TECHNICAL SERVICE BULLETIN

Soft Top Wear Above B-Pillar

22-
2274

Ford
2021-2022 Bronco

Figure 1

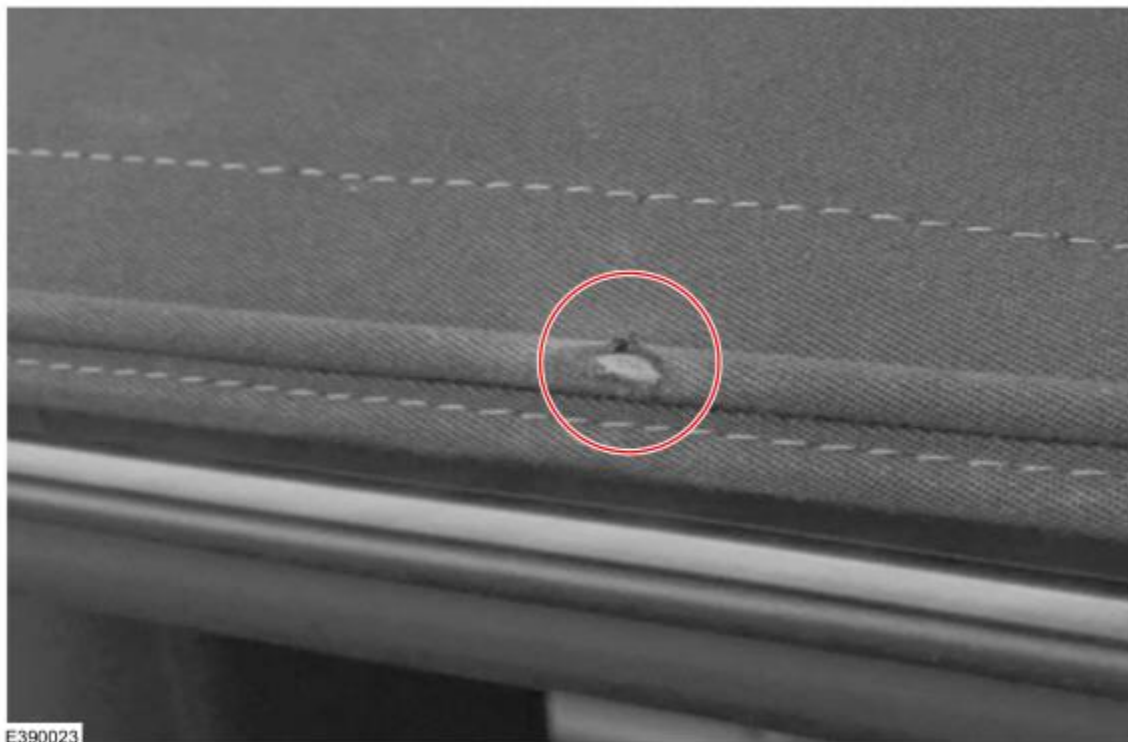
Issue: Some 2021-2022 Bronco vehicles equipped with a soft top may exhibit exterior wear on the sides of the top above the B-pillar. This may be due to contact and rubbing between the soft top frame and fabric. To correct the condition, follow the Service Procedure to replace both right and left deflectors attached to the soft top frame and soft top cover.

1. Does the soft top exhibit wear above the B-pillar similar to Figure 1?

(1). Yes - proceed to Step 2. Updated deflectors will be installed on both sides of the soft top frame assembly to prevent wear.

Figure 3

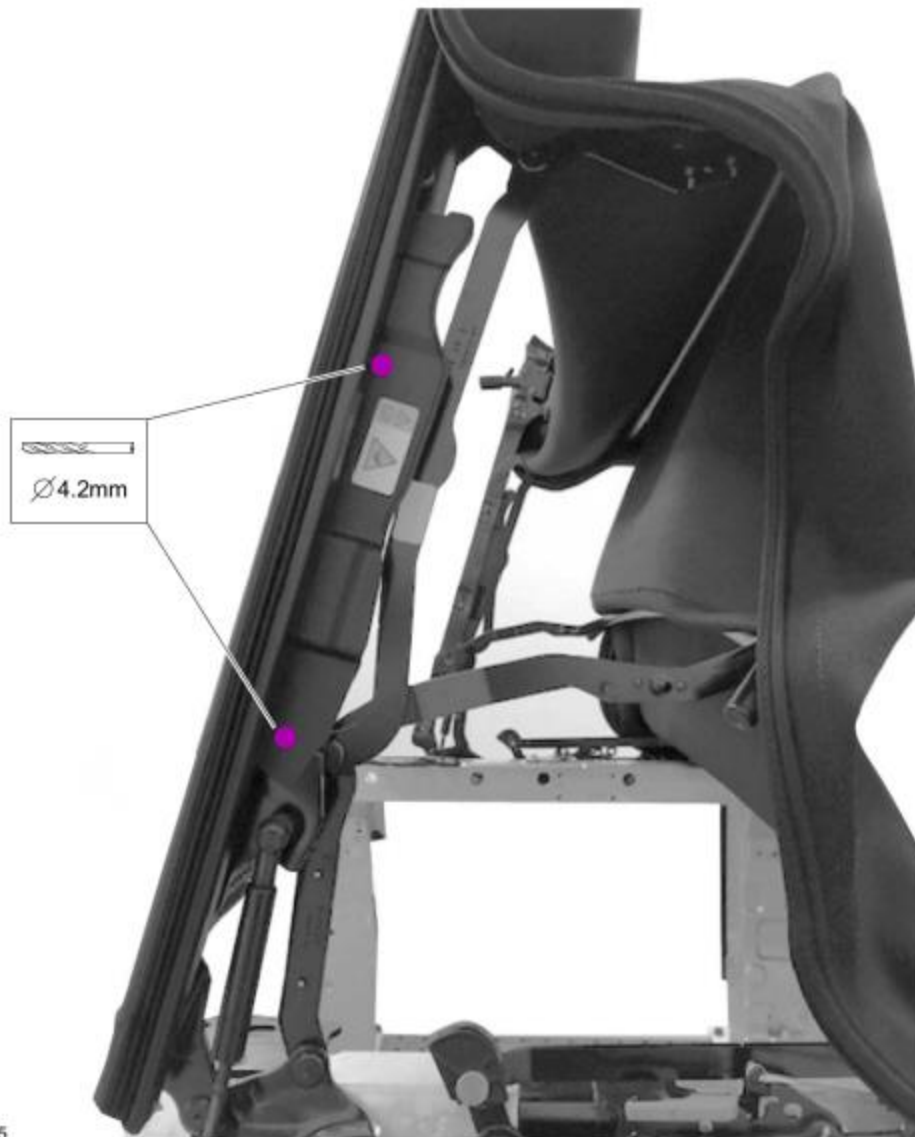
**CAUTION:** Do not drill through the linkage assembly. Only the head of the rivet should be drilled. Drilling through the linkage enlarges the hole where a new rivet will not fit to secure the linkage.

4. Locate each deflector on the right and left side of the frame assembly and drill out 2 rivets per deflector using a 4.2 mm (11/64 in) drill bit. (Figure 3)

5. Attach an updated deflector on each side of the frame using rivets, securing the new deflector to the frame assembly starting from the front moving to the rear.
6. Remove and replace the soft top cover. Refer to the Workshop Manual (WSM) Section 501-18A Soft Top > Removal and Installation > Soft Top Material.

Figure 4

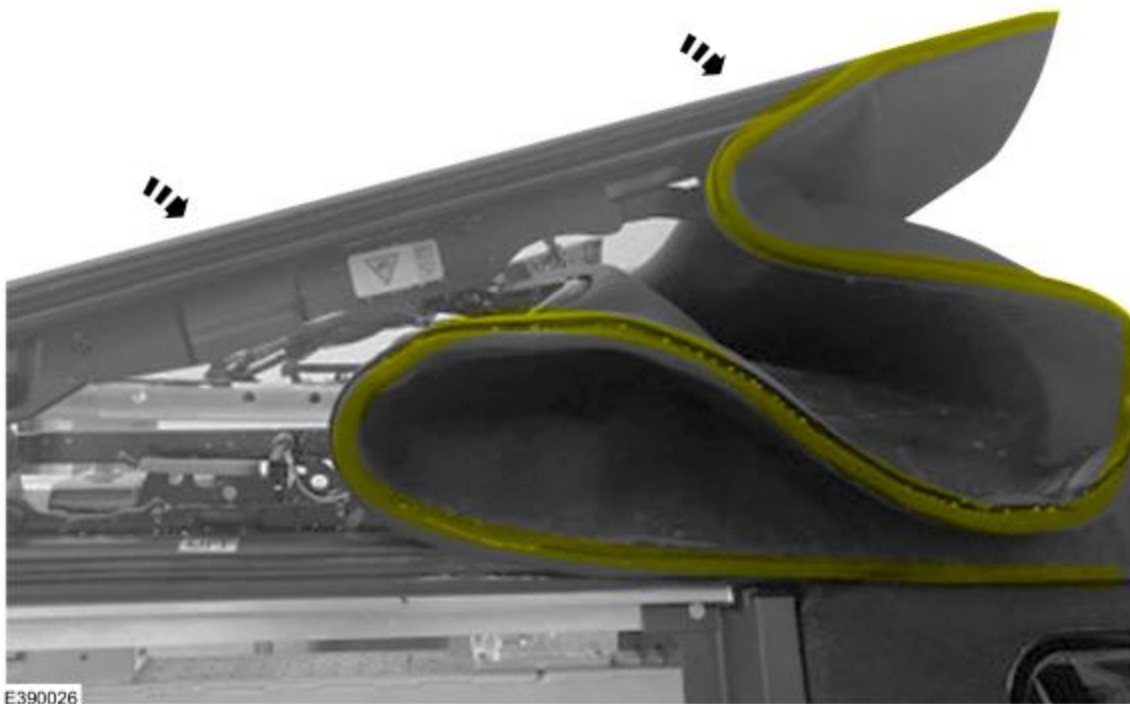
NOTE: When placing the soft top in the stowed position, make sure the fabric is positioned in an S pattern. (Figure 4)
